Kildare County Council

Planning Report

25/124

Name of Applicant	Aileen & Michael Moloney
Address of Development	1 The Meadows, Newtown Manor, Kill
Development	Infill Residential
Type of Permission	Permission
Date Inspected	12/08/2025.
Due Date	03/09/2025.

Proposed Site Layout Plan

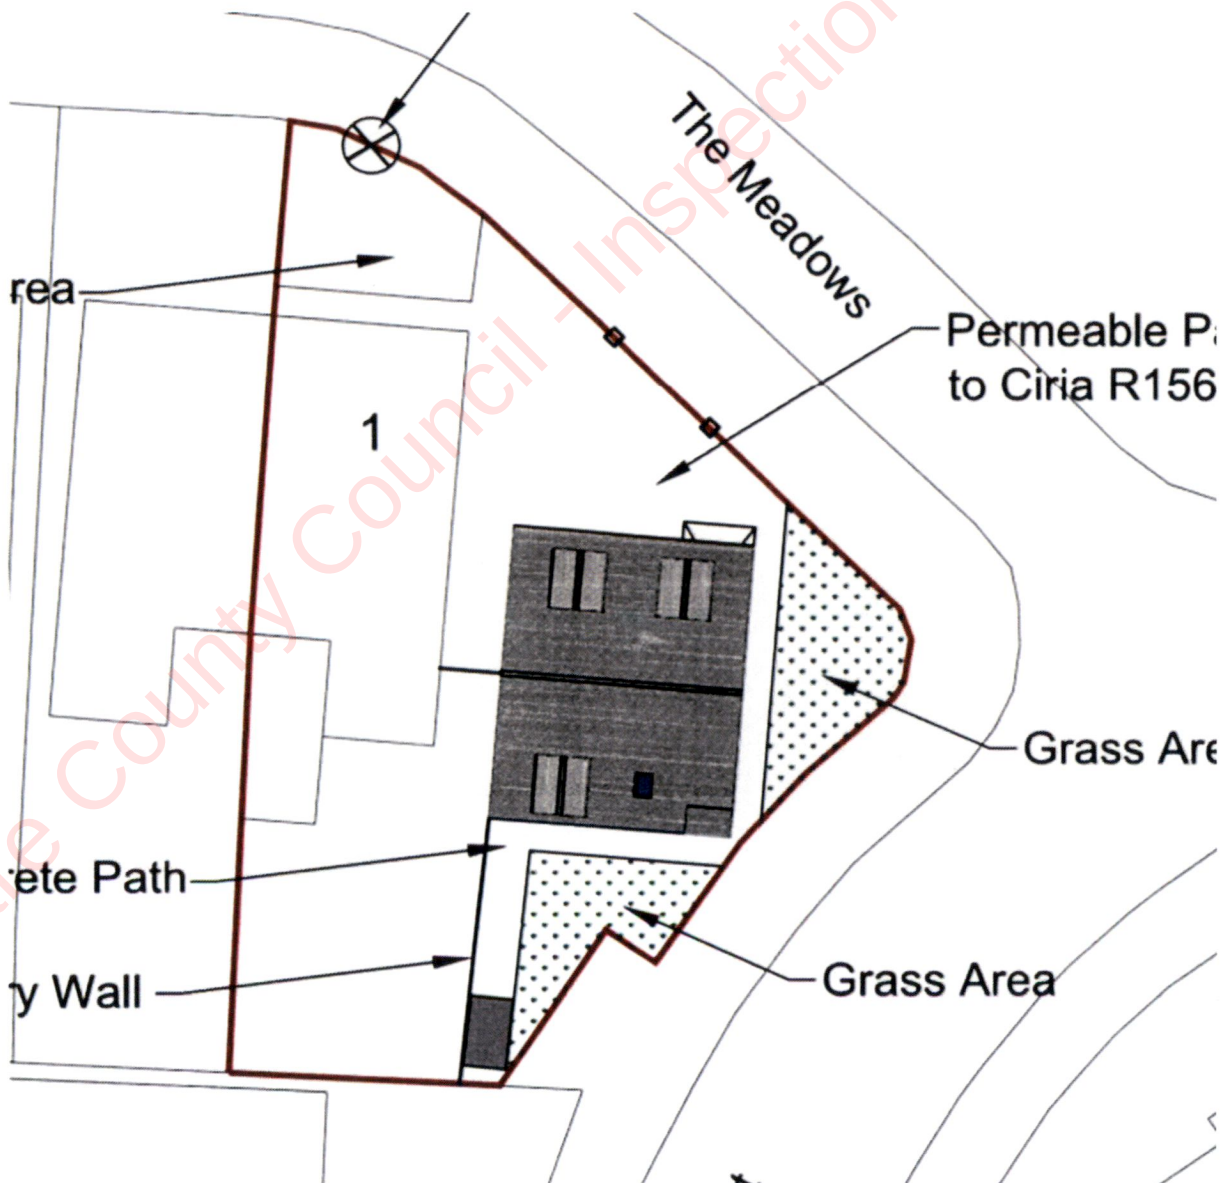
The applicant proposes to subdivide the existing site and to construct a detached 127sqm, two-bedroom, detached, dormer dwelling in the side garden of No. 1 The Meadows. However, it is unclear from the Site Layout Plan or the submitted documentation received with the application how the site is to be subdivided and is therefore a full assessment cannot be carried out. **Further Information.**

(a) Submit a revised Site Layout Plan clearly delineating how the site is to be separated between the existing and proposed dwelling. Indicate the curtilage of both dwellings and all proposed boundary treatments.

Proposed front and side elevations – Side elevation would present and be prominent as one approaches the site.

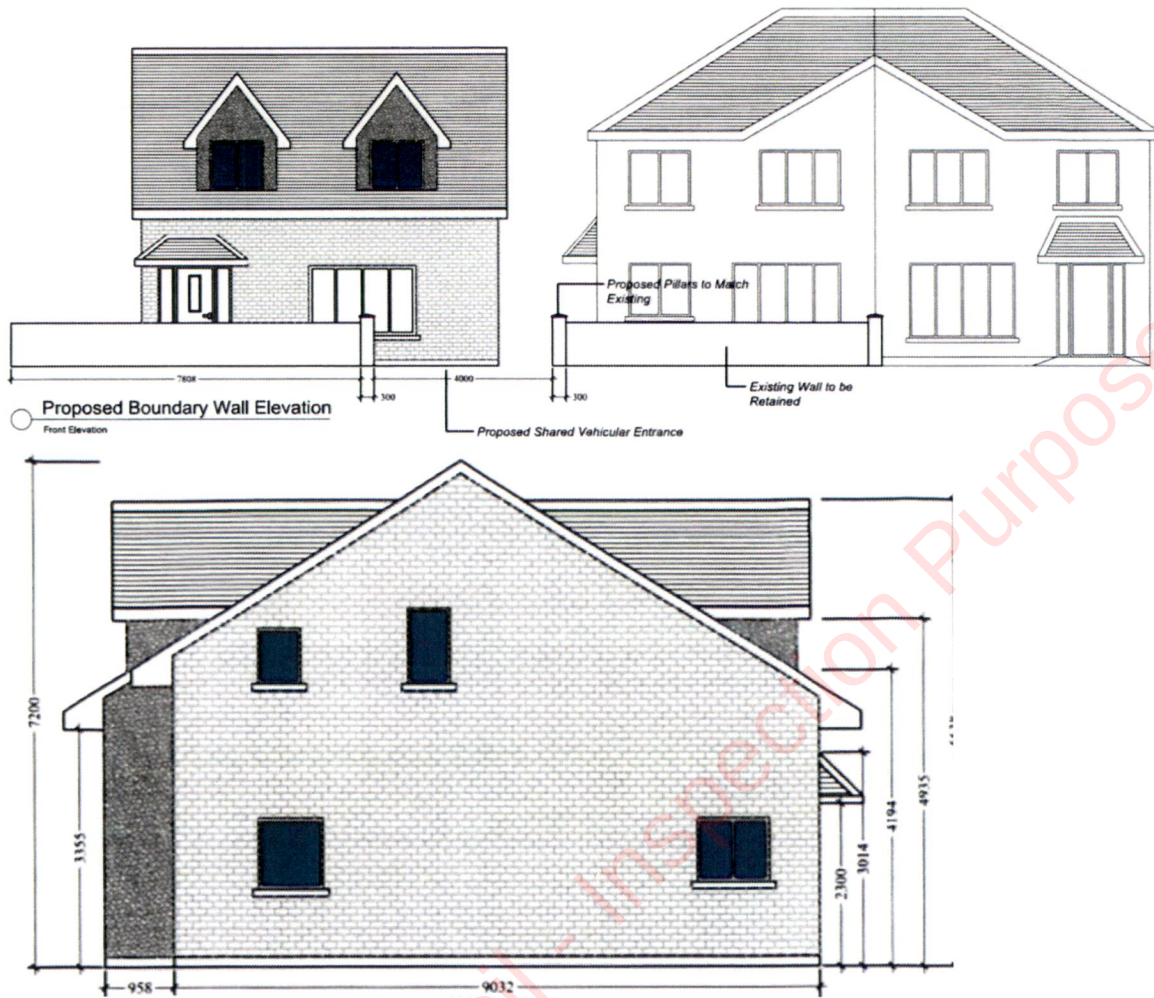
Site is located on a prominent corner and will be highly visible on approach.

Objective UD O1 of the Kildare County Development Plan 2023-29 requires *inter alia* a high standard of urban design and layout in all new development. In this proposal materials proposed are to match existing. Aside from this, the design fails entirely to respond to its context and therefore would represent a visually incongruous and

discordant addition to The Meadows contrary to UD O1. Any proposed development on this prominent corner site will require a higher standard of design due to its highly visible location. The design at this location will need to be well-thought out and designed to address the streetscape that wraps around the site. This is not the case in the proposed development. A full redesign is required. **Further information.**

The Applicant should be requested to redesign the proposal to better integrate visually into the site and to respond more effectively to its wider surroundings. Active frontage and side elevations should be integrated. Prior to submission of this complete redesign, the applicant needs to consider the prominence of the site and how it can satisfactorily address all the streets onto which it would face.
